**SAFE  
CLEAN  
WATER  
PROGRAM**

**Stormwater  
Investment Plan  
South Santa  
Monica Bay  
Watershed Area**

**Fiscal Year 2025-2026**

## 1.4 Project Modification Requests (PMRs)

Figure 1 – Original Concept Design Layout

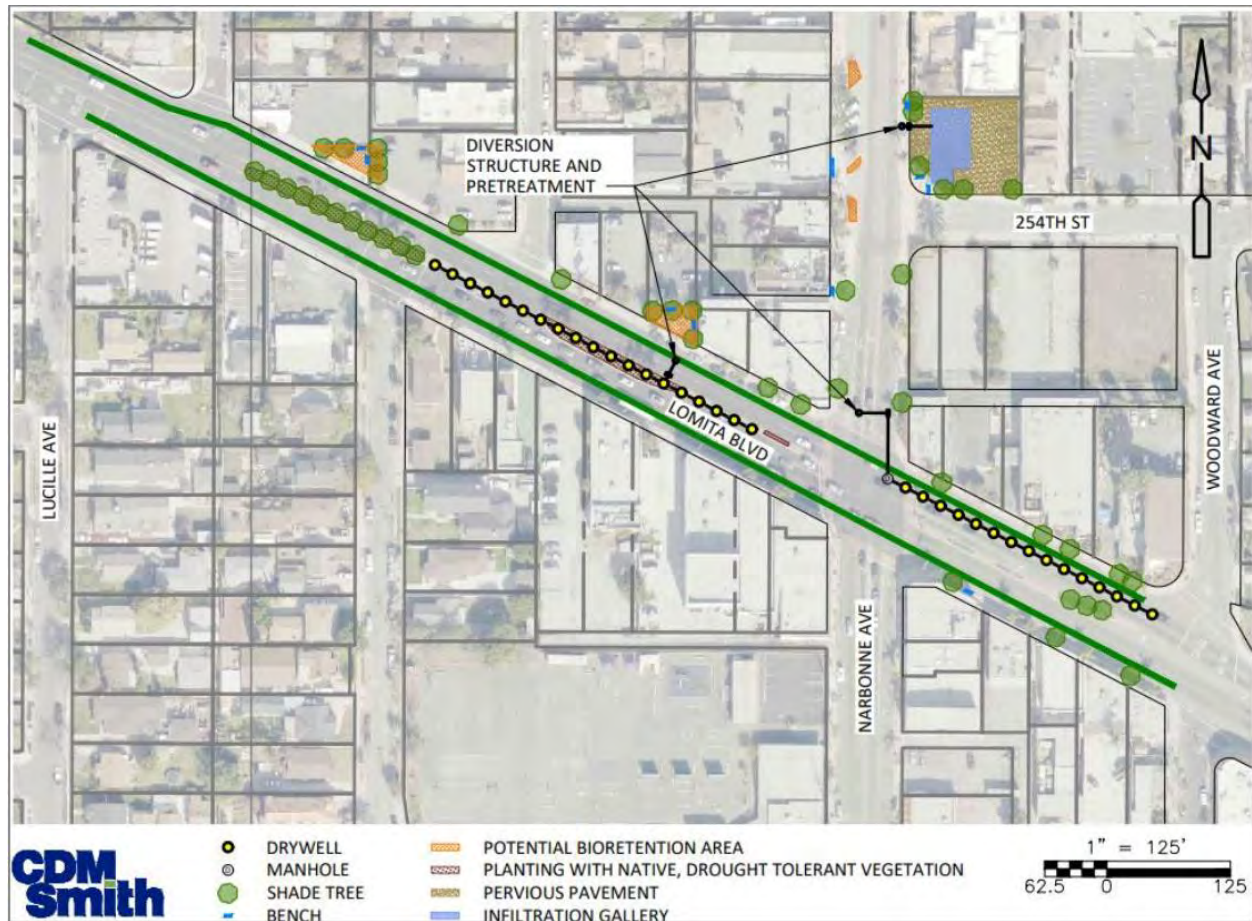
As shown in Figure 1, the original concept design begins on Narbonne Avenue and extends 450-feet south to Lomita Boulevard. It continues along the 1,100-foot length of Lomita Boulevard from Lucille Avenue to Woodward Avenue. The Project was intended to capture and infiltrate stormwater flow by infiltrating stormwater under a City-owned parking lot on Narbonne Avenue and in drywells under Lomita Boulevard. Other key components of the Project include the planting of 45 trees along Narbonne Avenue and Lomita Boulevard, new vegetated areas along the sidewalk and in the medians that will further capture stormwater in a natural way, and bioretention along Narbonne Avenue. Community aspects of the original design included benches, and the addition of a bike lane along Lomita Boulevard from Woodward Avenue to Lucille Avenue. Additional bike locking locations would also be provided in key locations to further encourage this healthy mode of transportation.

In October of 2020, geotechnical investigations were conducted at 2154 245th Street, directly adjacent to the proposed infiltration gallery location at the City-owned parking lot at 24418 Narbonne Avenue. Based on this investigation, an infiltration rate of 16.9 inches per hour (in/hr) was used to provide preliminary sizing for the infiltration best management practices (BMPs). The Project planned to capture and infiltrate 5.6 acre-feet (ac-ft) of stormwater over a 110-acre drainage area. 1.72 ac-ft would be captured by an infiltration gallery, 3.95 ac-ft by dry wells, and 0.03 ac-ft by surface BMPs. For further information regarding the original concept design, refer to the feasibility report included in Appendix A.

Figure 5 – Geotechnical Investigation Near Lomita City Hall

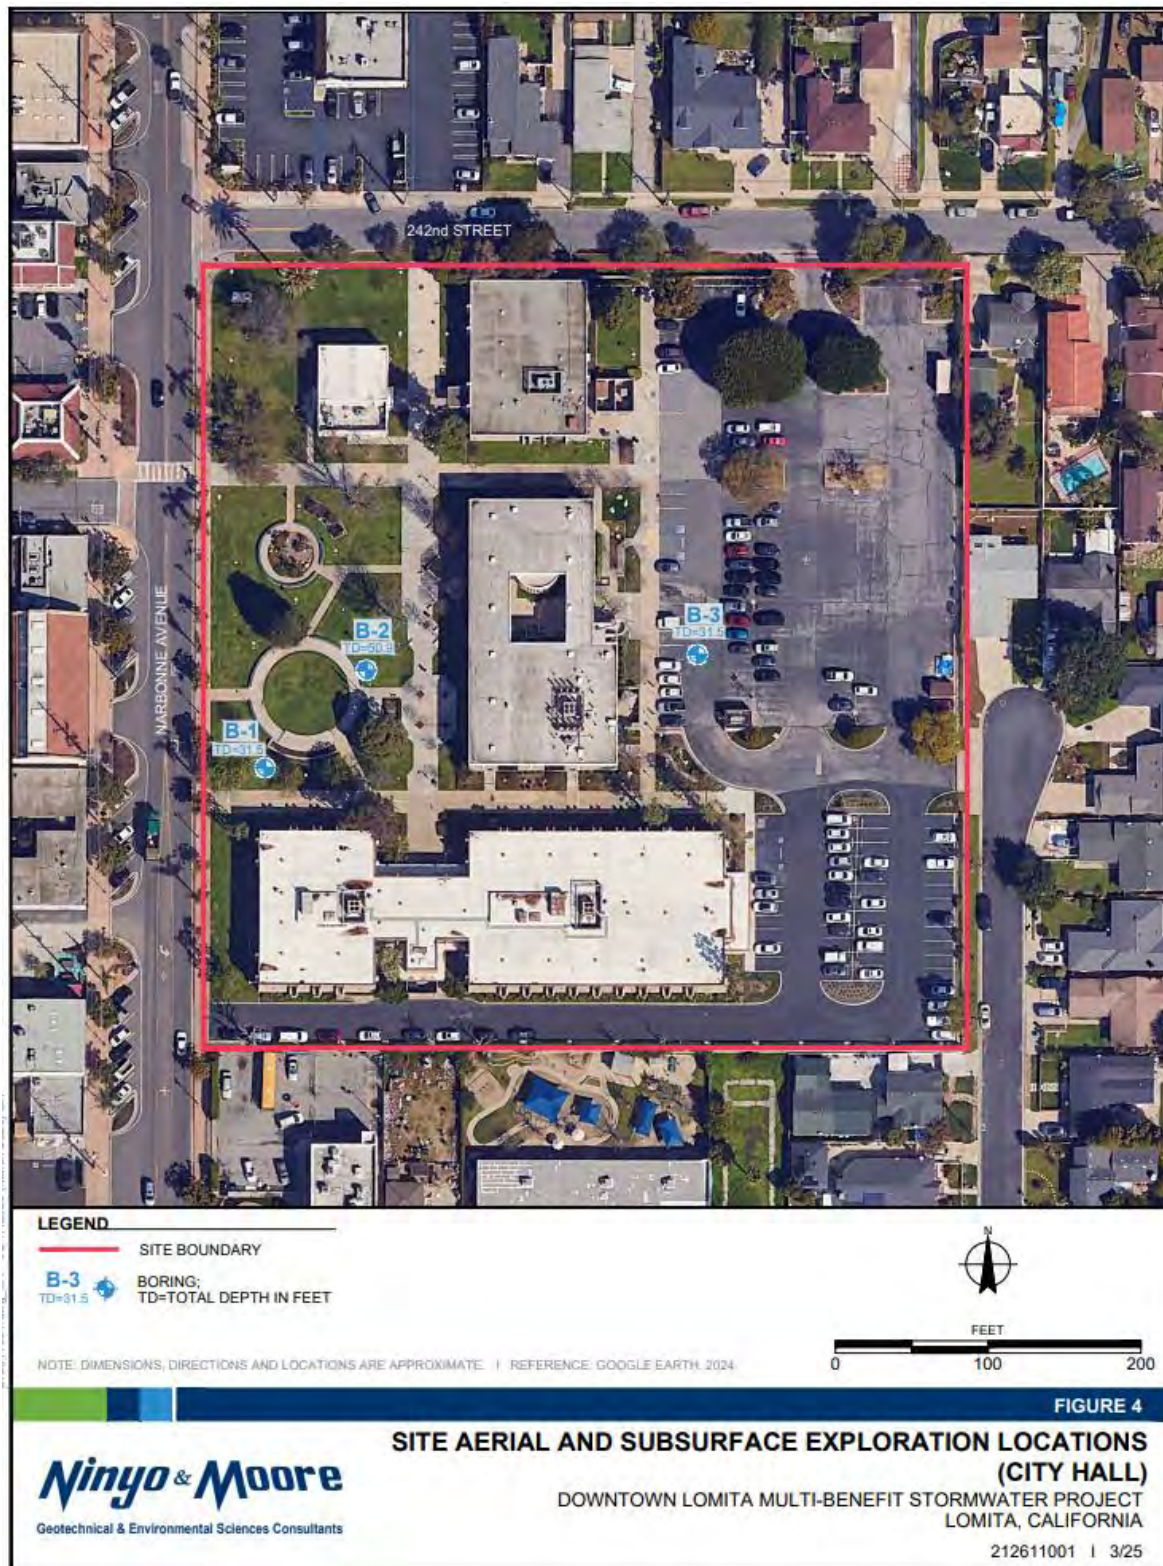
borings at two different depths at the City Hall locations. Figure 5 illustrates the precise locations and depths of these geotechnical testing sites.

A conceptual design for the proposed alternative is presented in Figure 5. This design includes a single diversion to capture the entire Project drainage area and incorporates a submersible pump station on Lomita Boulevard. Flow would be conveyed from the diversion to the proposed subsurface infiltration BMPs located at Narbonne Plaza and City Hall. The footprint required for an infiltration gallery installation is estimated at approximately 18,500 square feet with an internal gallery depth of 14 feet, including 1 foot of freeboard. It is anticipated that only the front of City Hall will be required but the back of City Hall provides additional space if needed. The Narbonne Plaza and City Hall subsurface infiltration BMPs are anticipated to be hydraulically connected.
